Permit Number: 070238

has permission to Extend front deck from 6' to Griffin

Proposed Use: Single Family Home -Extend front deck from 6' to 10.94' Griffin Cove Side (Connected to permit #01-0047)	Proposed Project Description: Extend front deck from 6' to 10.94' Griffin Cove Side - the 4' x 15' ramp is not part of the permit.
--	--

CLIENT
JOSEPH & PATRICIA BENNETT RESIDENCE
 CLIFF ISLAND, MAINE
 PROJECT
Decking Plan

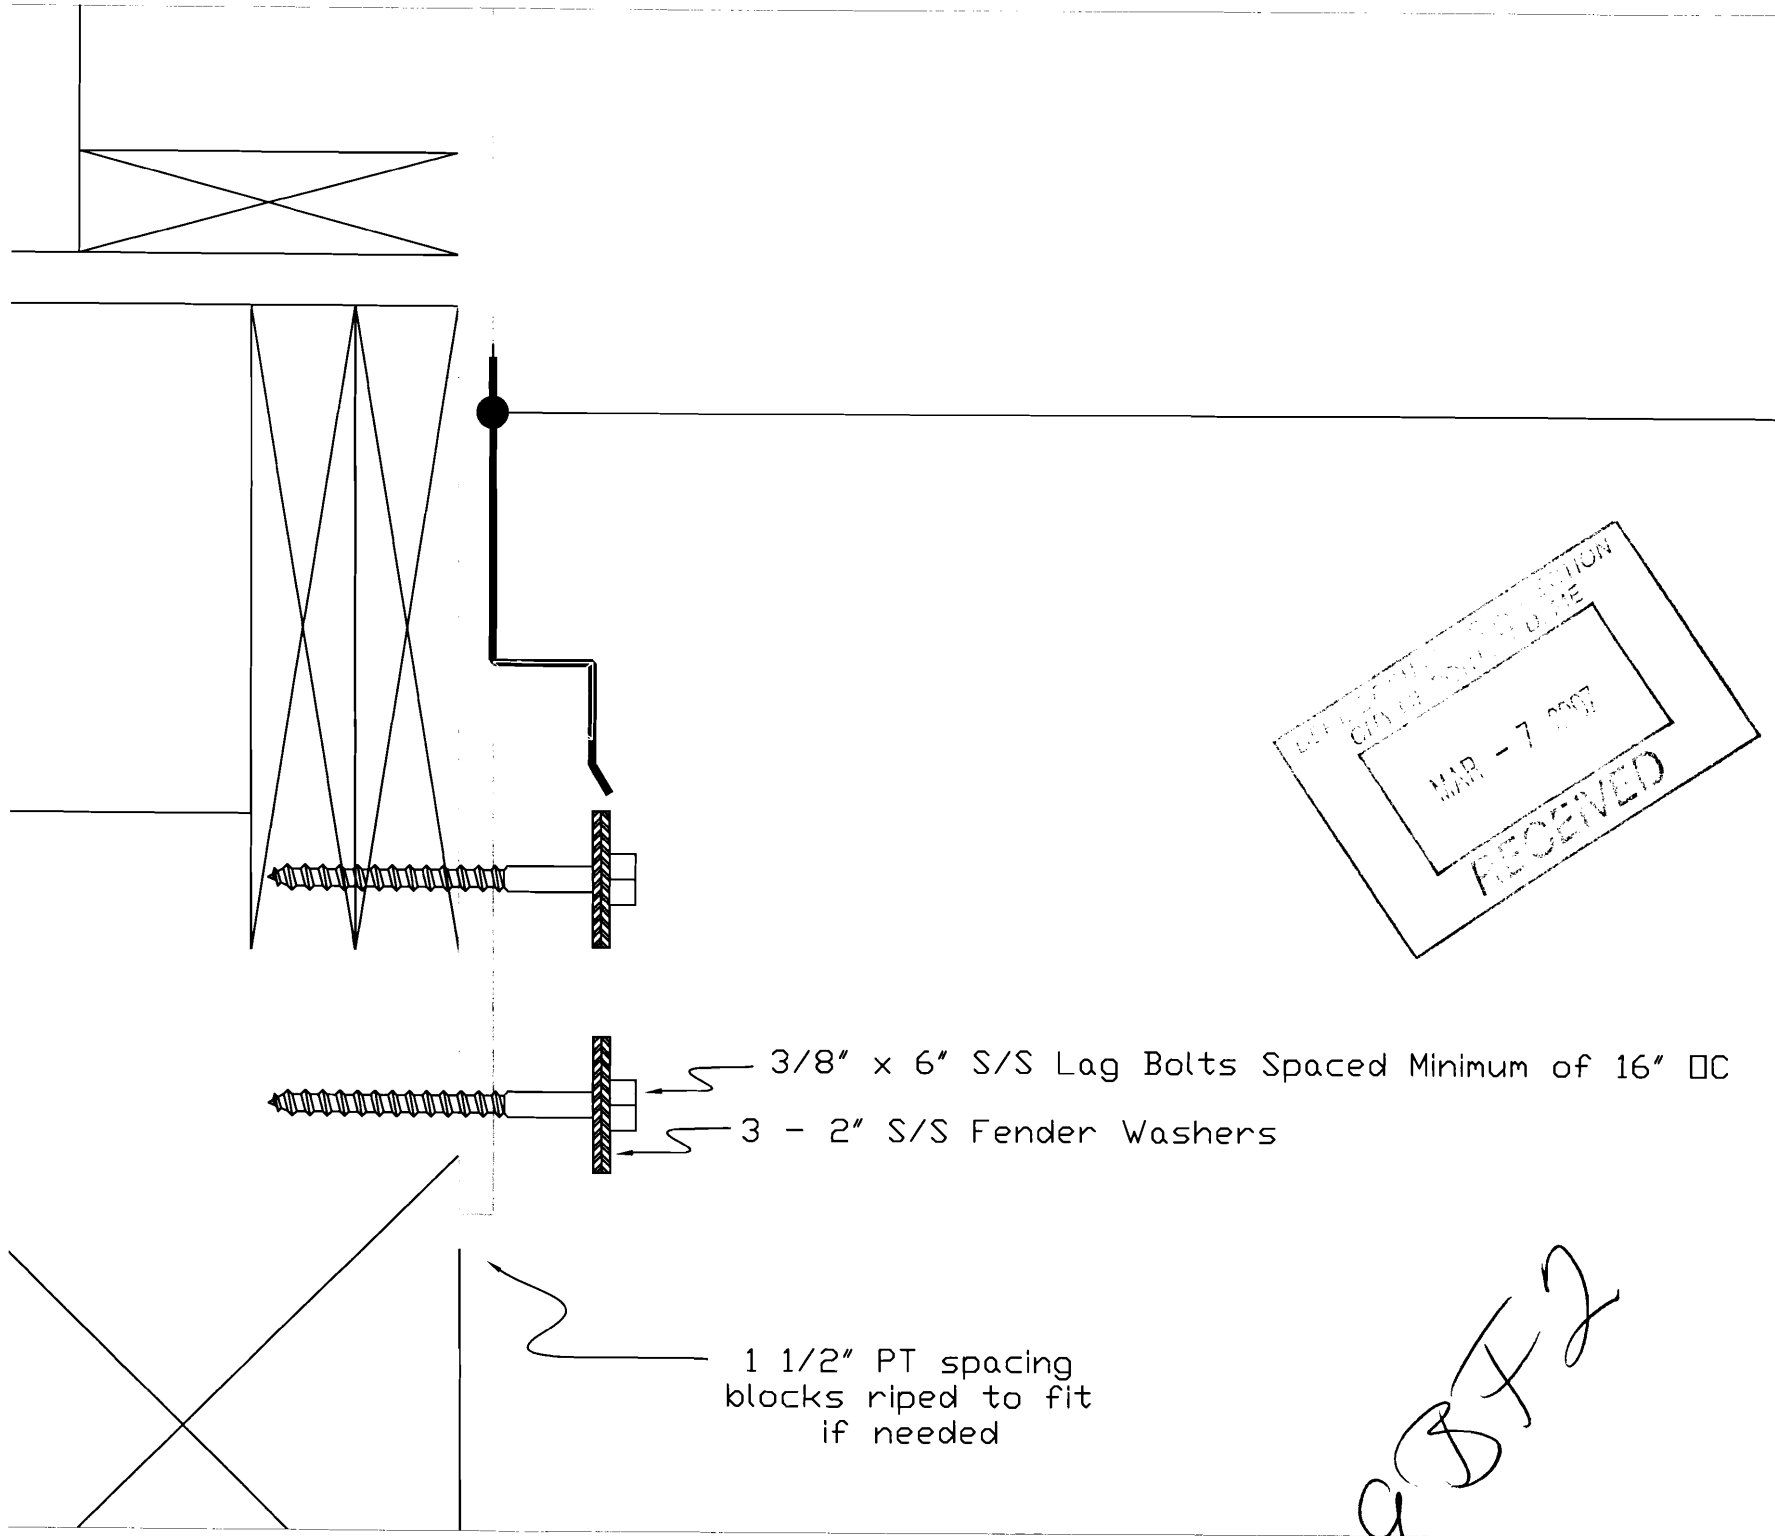
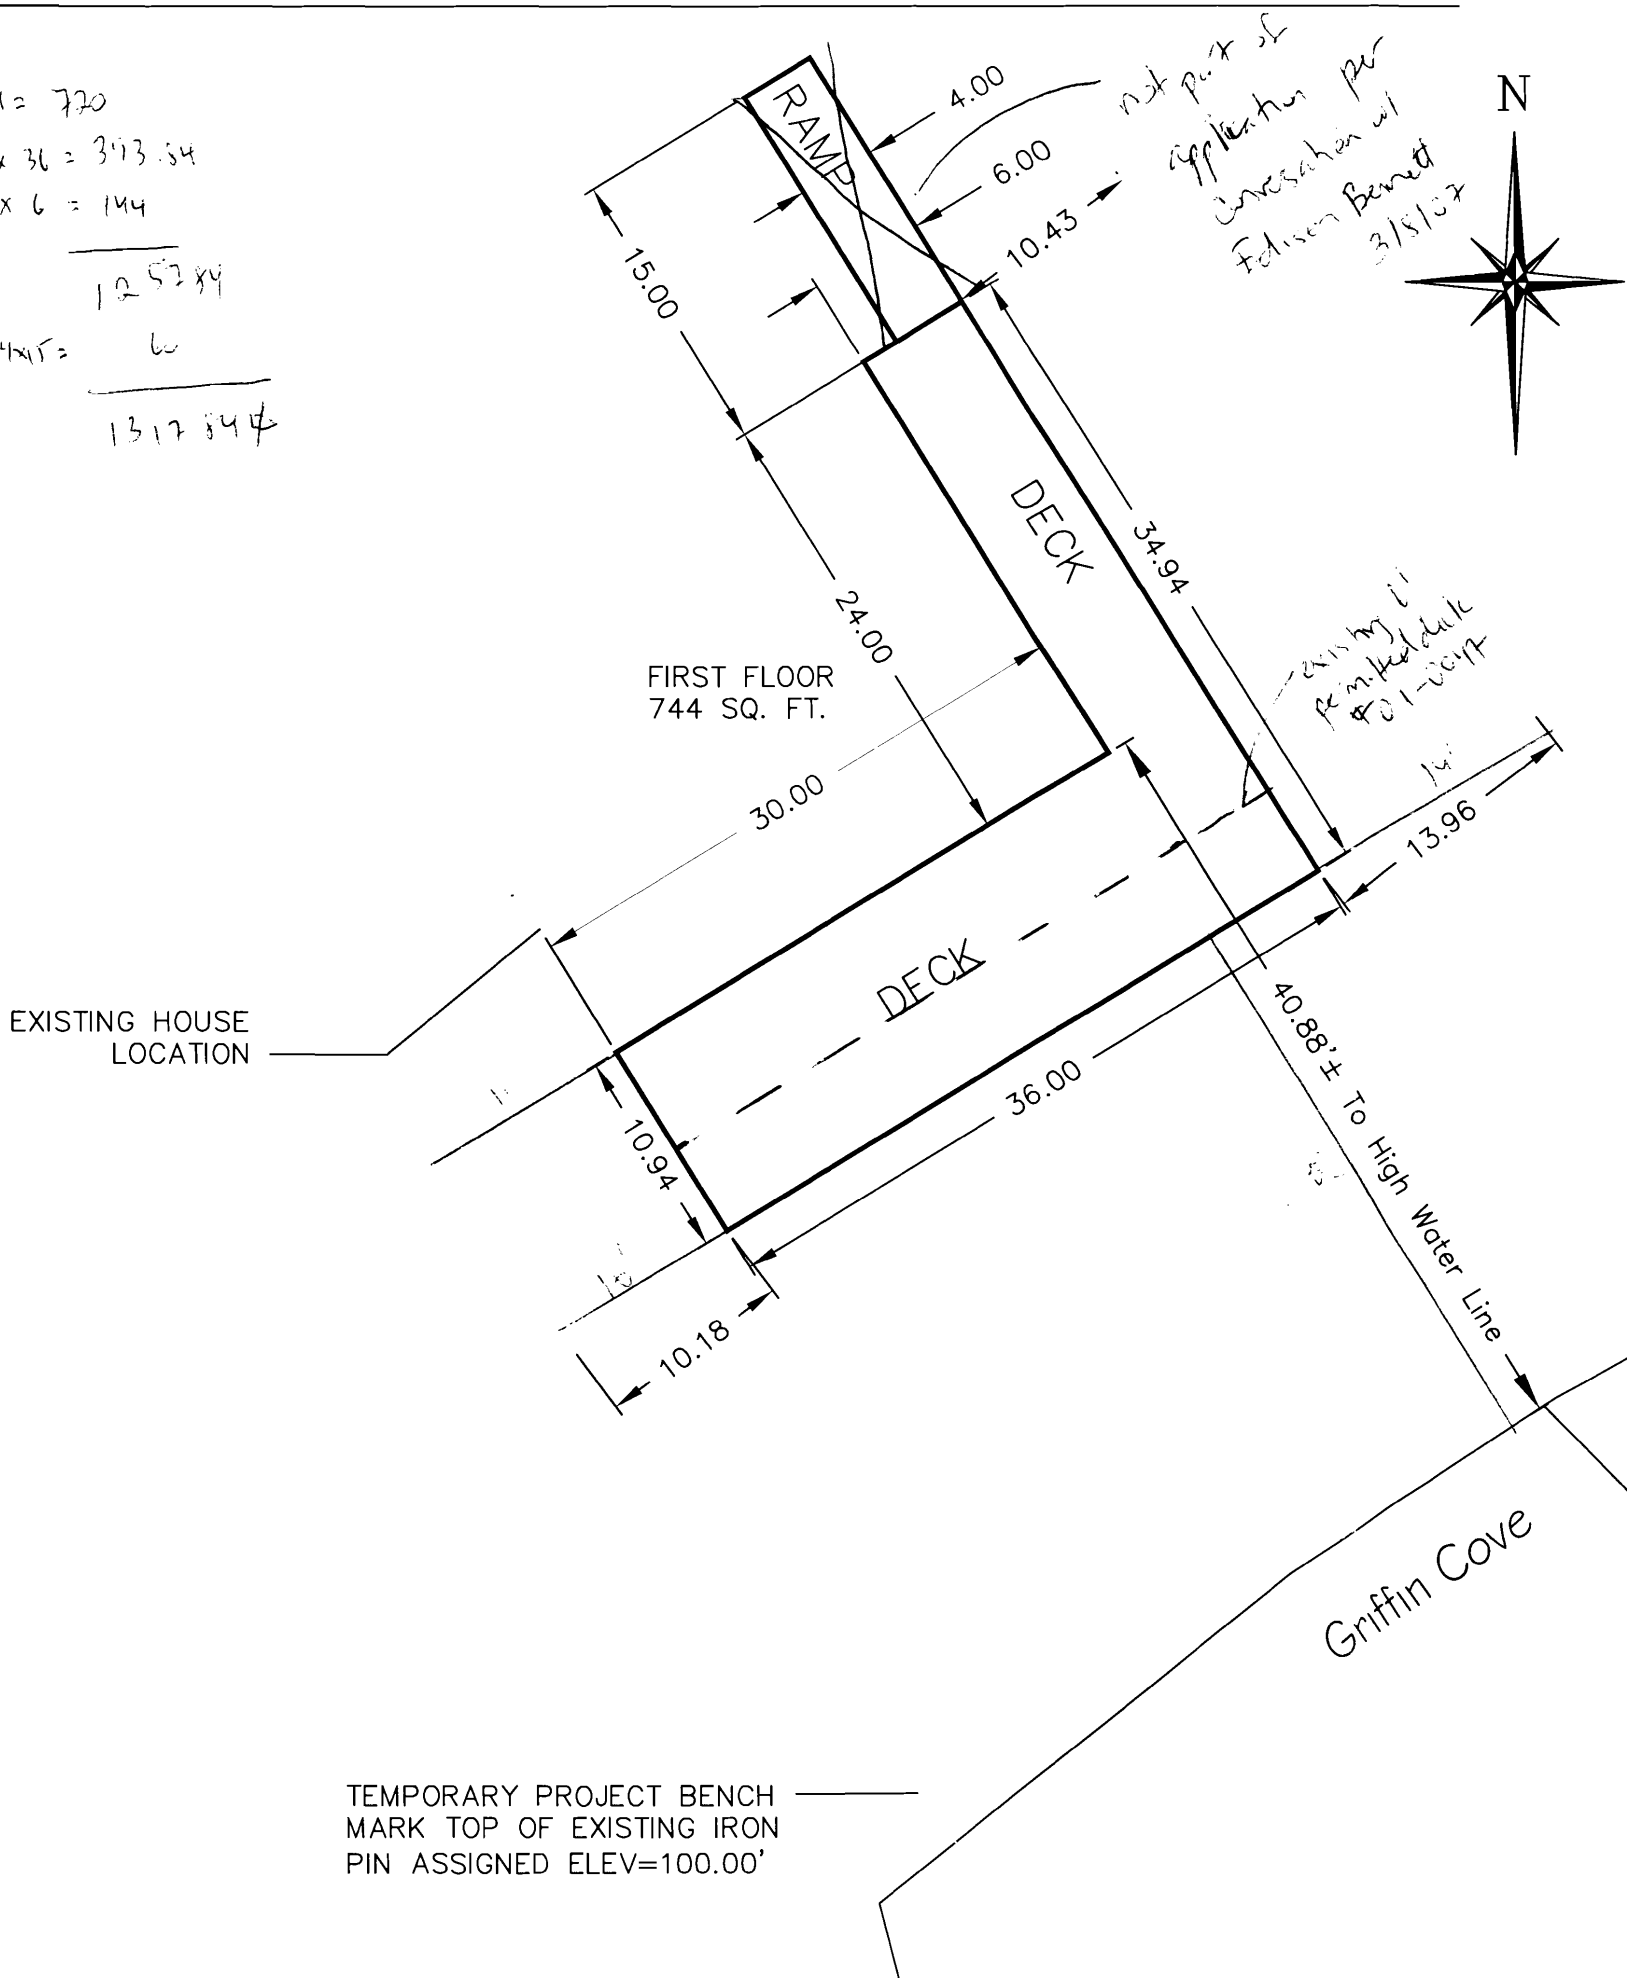
- 1) This permit is being approved on the basis of plans submitted. Any deviations shall require a separate approval before starting that work.
- 2) This permit is being issued with the understanding that there will not be a 4' x 15' ramp from the deck to the street.

- 1) Fastener schedule per the IRC 2003
- 2) Open risers are permitted, provided that the opening between treads does not permit the passage of a 4" diameter sphere.
- 3) As discussed during the review process, ballusters must be spaced with less than a 4" opening between each.
- 4) This permit is issued based on the plans submitted. Variations in actual construction that effect grades may change the requirements for handrails and guards.

3/8/2007-amachado: Spoke to Edison Bennett. I told him that the proposed 4' x 15' ramp does not meet the zoning requirements. He told me to remove the ramp from the siteplan and permit application.
